SUBJECT: Second Ten Year Inservice Inspection Program

Byron Nuclear Power Station, Units 1 and 2
Facility Operating Licenses NPF-37 and NPF-66
NRC Docket Nos. 50-454 and 50-455

ATTACHMENT 1
RAI QUESTIONS AND RESPONSES

ATTACHMENT 3
REVISED RELIEF REQUESTS

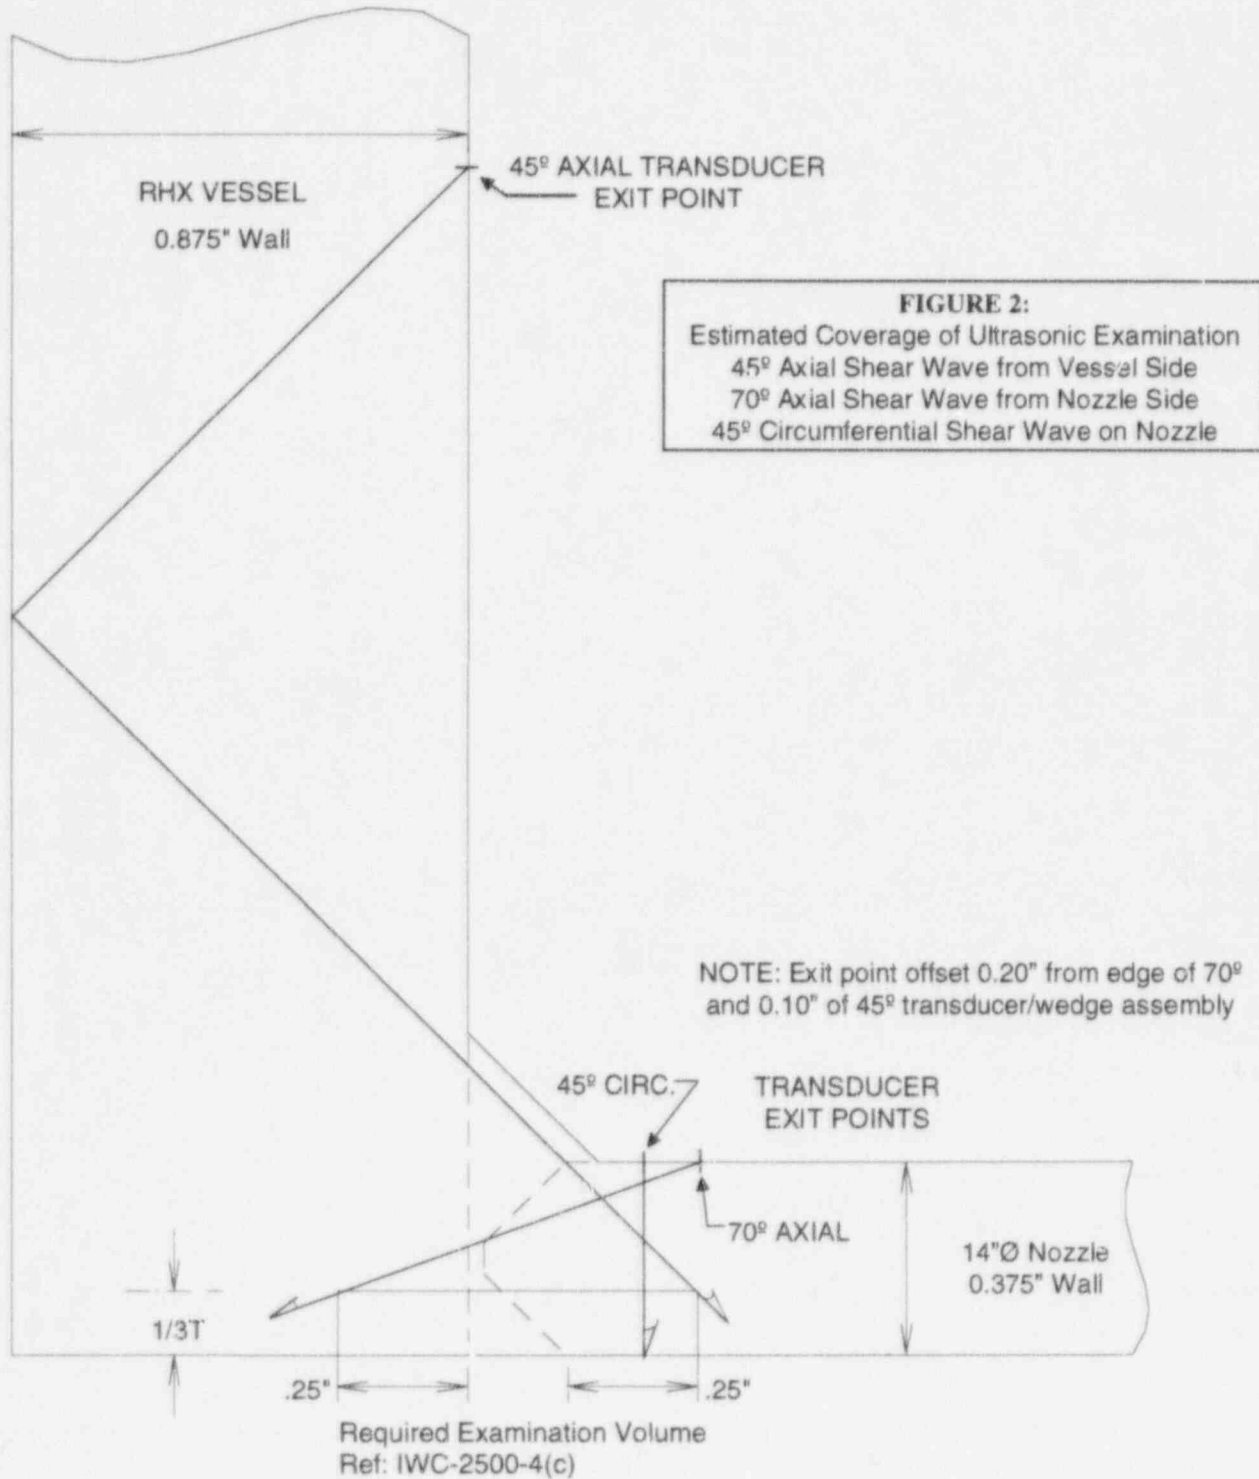
The "best effort" ultrasonic examination will primarily be performed from the nozzle outside surface. Anticipated obstructions include the reinforcement fillet weld located directly above the nozzle-to-vessel weld. This fillet weld restricts inspection transducer movement and limits available examination angles. A 70° transducer will be used on the nozzle side of the weld to pass sound under the fillet weld to reach the lower $\frac{1}{3}T$ of the pressure retaining weld. Scanning from the vessel side of the weld will be accomplished by use of a 45° shear wave transducer on the shell surface to reach the examination volume. These scans are in the axial direction of the nozzle-to-vessel weld. Scans in the circumferential direction will be very limited due to the location of the fillet weld. This weld location does not allow the transducer to scan over the entire examination volume from the outside of the nozzle. It is estimated that 99.92% of the examination volume will be reached in the axial direction. With the limited circumferential scans (13.29%), the total scanning percentage is estimated at 56.61%. See Figure 2 of this report for scan coverage plots.

(Page 4 of 7)
 Figure 1

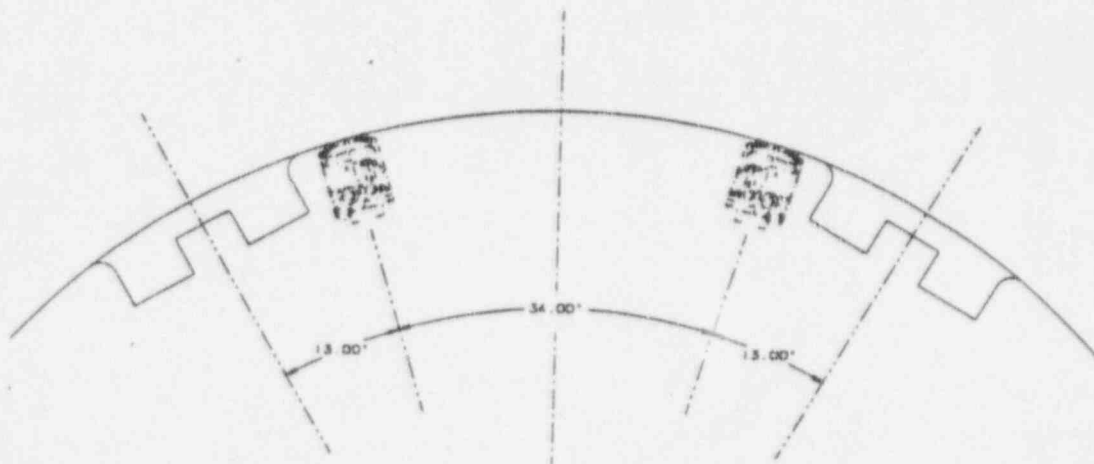
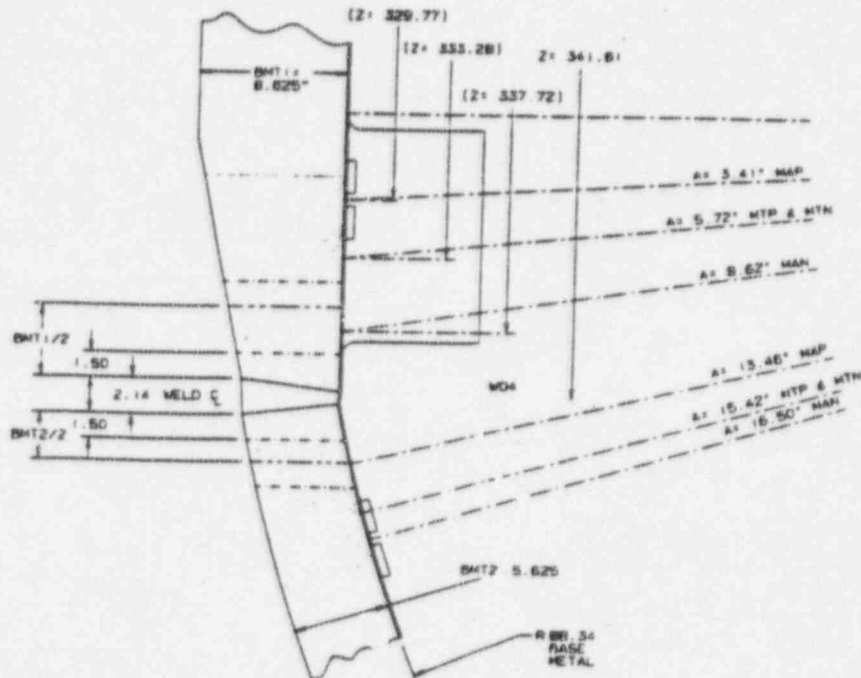
The examination of the Unit 1 Lower Shell Course-to-Dutchman weld, RPVC-WR29, is restricted by six (6) core barrel locating lugs welded to the inner surface of the vessel approximately 4 inches above the weld (See Figure 1). These lugs obstruct the automated UT inspection tool from examining the code required volume of the weld below each lug (156°). The FTI "URSULA" tool has a 6 degree movement arm and the physical size of the lugs and the "yaw" joint of the tool prevented scanning below the lugs back into the weld and surrounding base metal. All weld metal can be examined from both sides where access is available between the lugs (204°). Examinations for perpendicular and parallel reflectors covered areas accounting for 57% of the weld metal and heat affected zone (HAZ). Similarly, 57% of the weld metal can be examined for transverse reflectors from two opposing directions.

The examination of the Unit 2 Lower Shell Course-to-Dutchman weld, RPVC-WR29, is similarly obstructed (see Figure 1). All weld metal can be examined from both sides where access is available between the lugs (204°). Examinations for perpendicular and parallel reflectors can cover areas accounting for 57% of the weld metal and heat affected zone (HAZ). Similarly, 57% of the weld metal can be examined for transverse reflectors from two opposing directions.

BYRON STATION UNITS 1&2 FIRST INTERVAL
ISI PROGRAM PLAN-NRC SUBMITTAL
RELIEF REQUEST NR-20
(Page 5 of 7)
Figure 2

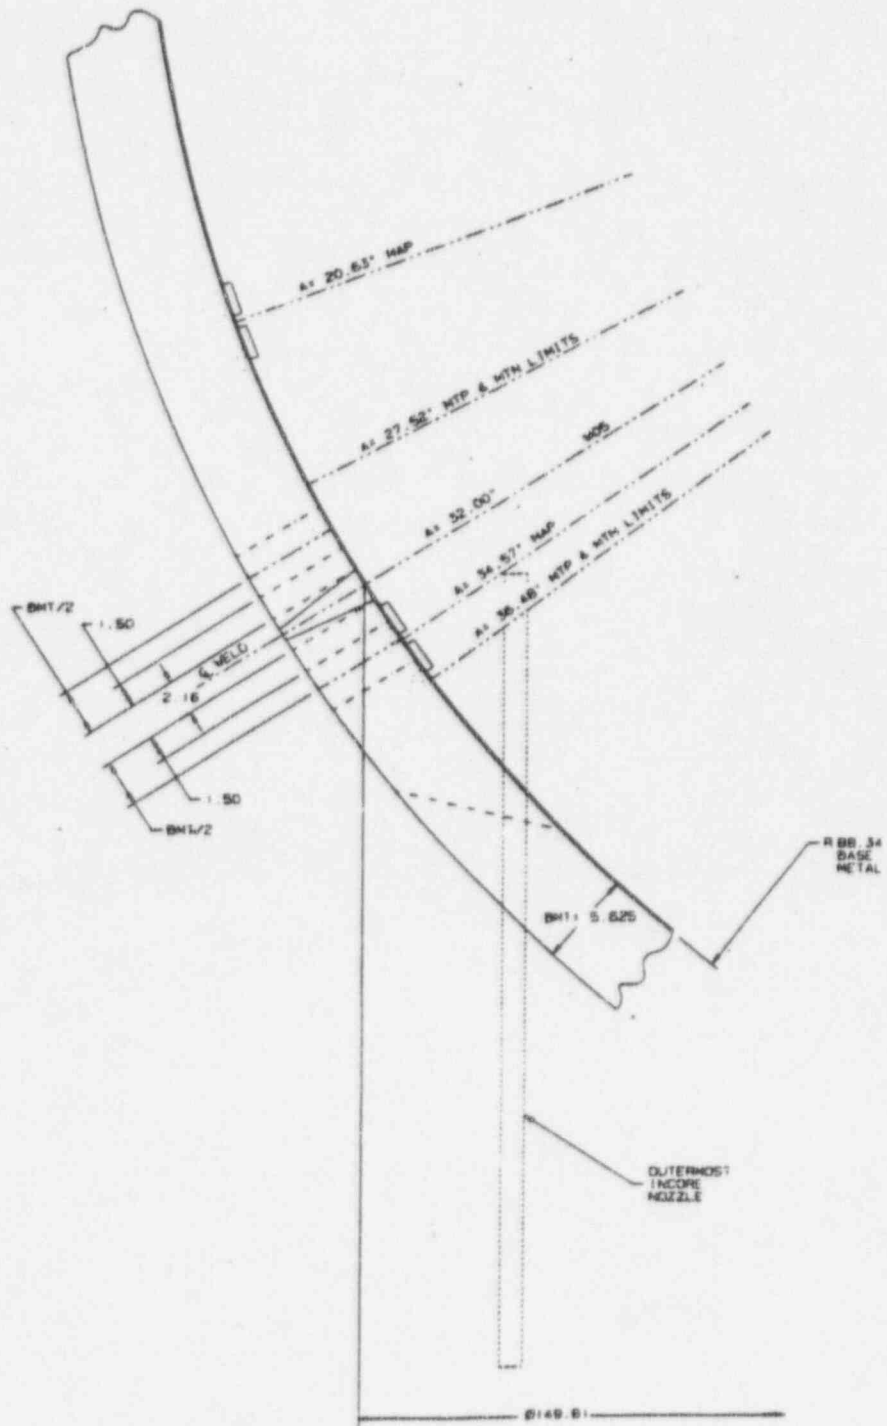
The examination of the Unit 1 Lower Disk-to-Dutchman weld, RPVC-WR16, is restricted by the 58 instrument tubes that penetrate the lower disk and physically obstruct the UT search unit and/or the search unit position device as shown in Figure 2 and 3. Approximately 19% of the weld length cannot be examined. The weld and the HAZ received essentially 100% coverage for parallel reflectors from the Dutchman side and for transverse reflectors in two opposing directions. Partial coverage is achieved for parallel reflectors from the disk side on the remainder of the weld resulting in an aggregate of all scan coverage of approximately 81%.

The examination of the Unit 2 Lower Disk-to-Dutchman weld, RPVC-WR16, is similarly restricted, see Figure 2 and 3. The weld and the HAZ will receive essentially 100% coverage for parallel reflectors from the Dutchman side and for transverse reflectors in two opposing directions. Partial coverage can be achieved for parallel reflectors from the disk side on the remainder of the weld resulting in an aggregate of all scan coverage of approximately 81%.

BYRON STATION UNITS 1&2 FIRST INTERVAL
ISI PROGRAM PLAN-NRC SUBMITTAL
RELIEF REQUEST NR-20
 (Page 7 of 7)
 Figure 4

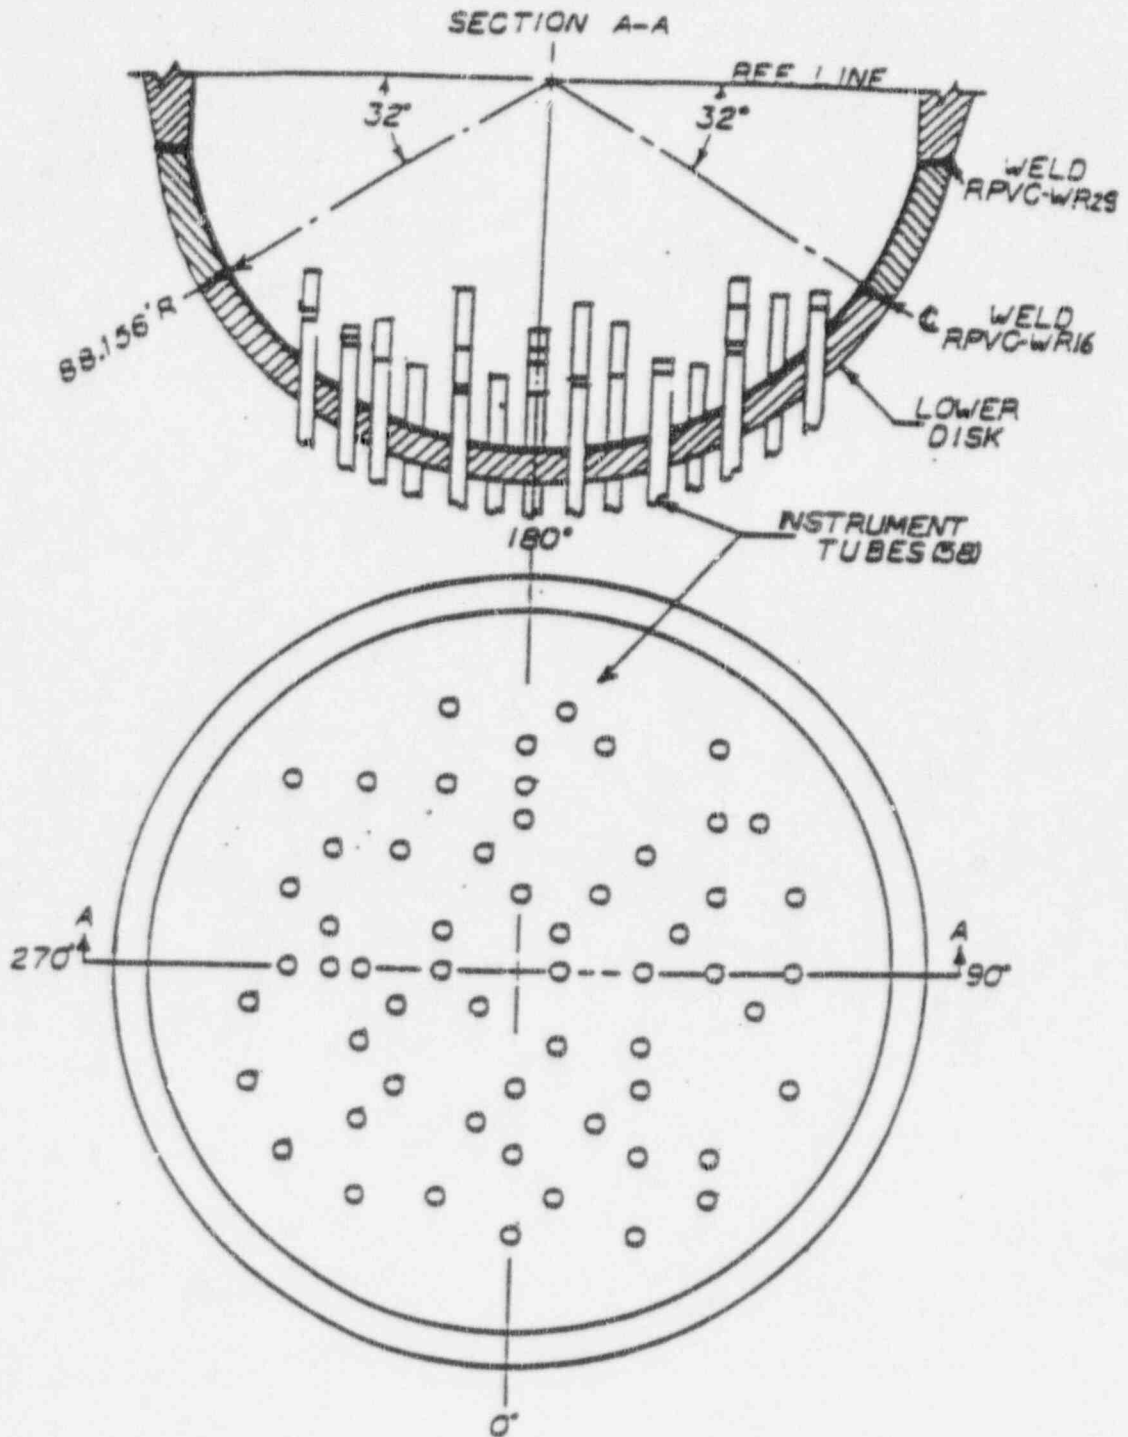
The examination of the Unit 1 Nozzle Shell Course-to-Flange weld, RPVC-WR7, is located immediately below the tapered portion of the flange which previously prevented 100% examination of the adjacent base metal weld (See Figure 4) based on Preservice Inspection (PSI) results. Coverage percentages indicated were not expected to improve with current examination techniques, however, automated examinations performed in B1R07, Spring 1996, achieved 100% coverage of required examinations. All of the code required weld volume and the adjacent base metal was examined for parallel reflectors.

The examination of the Unit 2 Nozzle Shell Course-to-Flange weld, RPVC-WR7, is similarly obstructed by the vessel flange taper per Figure 4. All of the code required weld volume and the adjacent base metal can be examined for parallel reflectors as shown in Figure 4.
